**STATE OF TENNESSEE
DEPARTMENT OF TRANSPORTATION**

INSTRUCTIONAL BULLETIN NO. 15-13

Regarding Revised Standard Drawings

Effective Apr. 1, 2016 letting (Jan. 20, 2016 Turn-in), the following Standard Drawings have been revised. Section V of the Design Guidelines is revised to incorporate these changes.

BREAKAWAY
POST
SIGN SUPPORTS

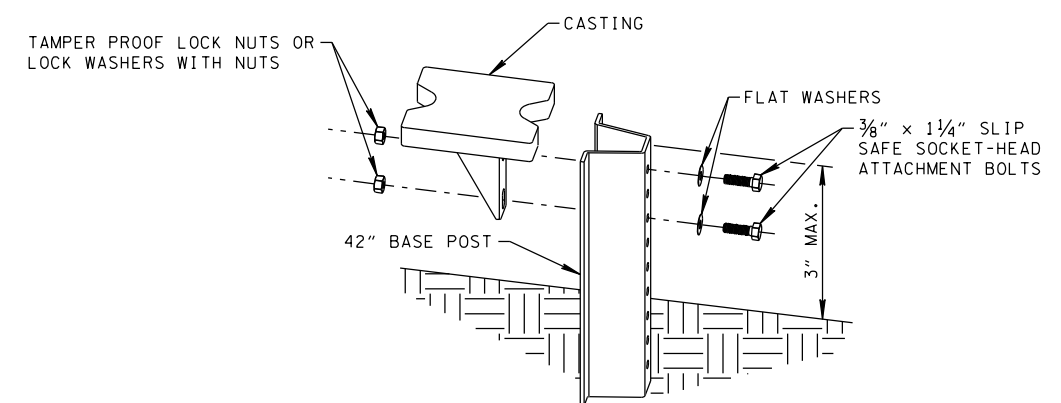
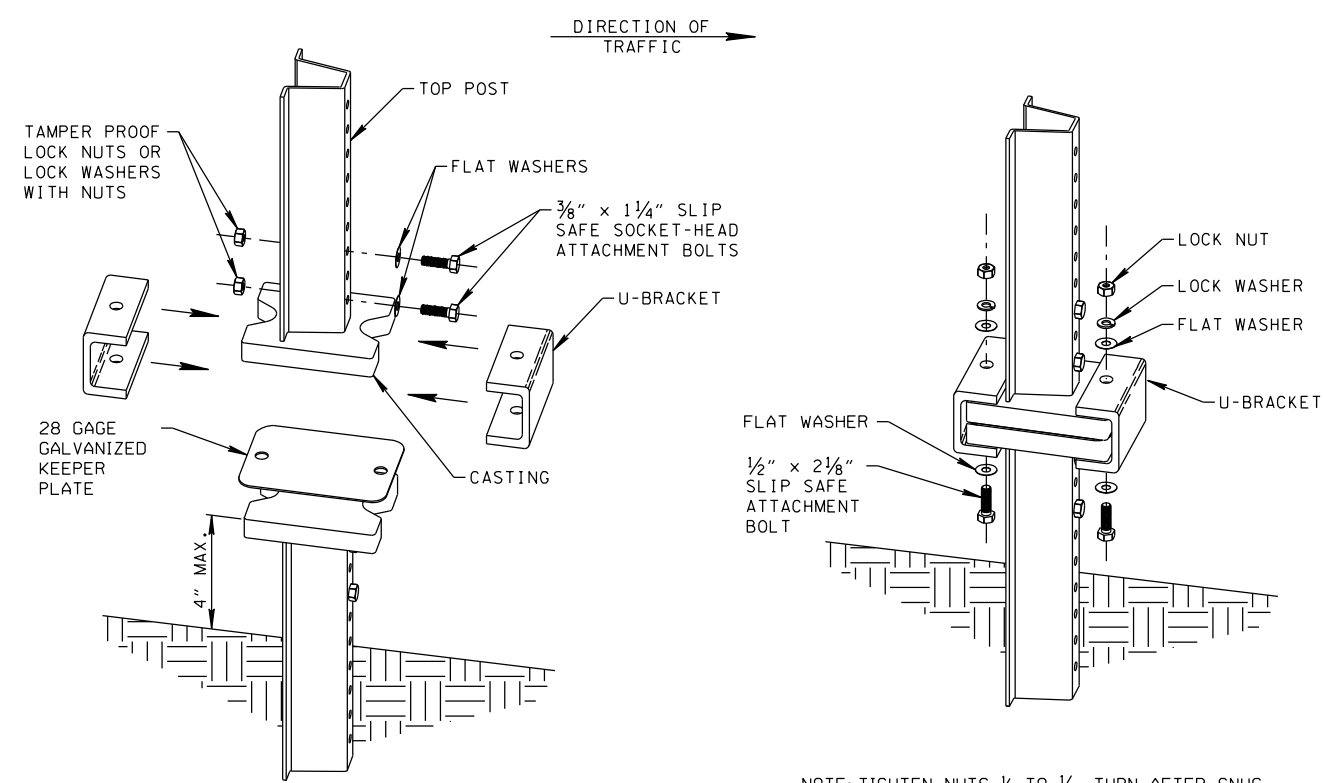
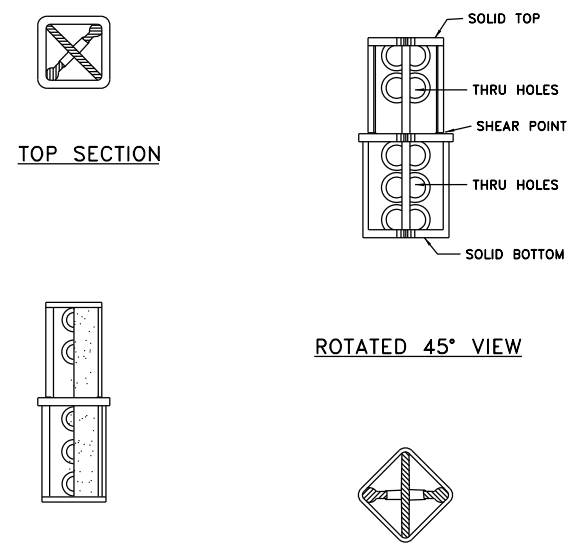
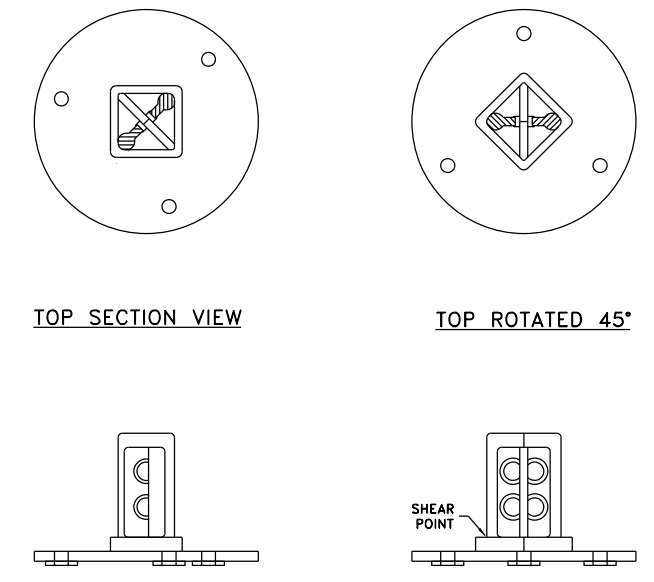
REV. 7-2-15: REVISED NOTE (L) AND ADDED NOTE (N) AND ADDED COUPLING DETAILS AND REVISED GENERAL NOTES. REV. 7-19-13: ADDED NOTE (M)
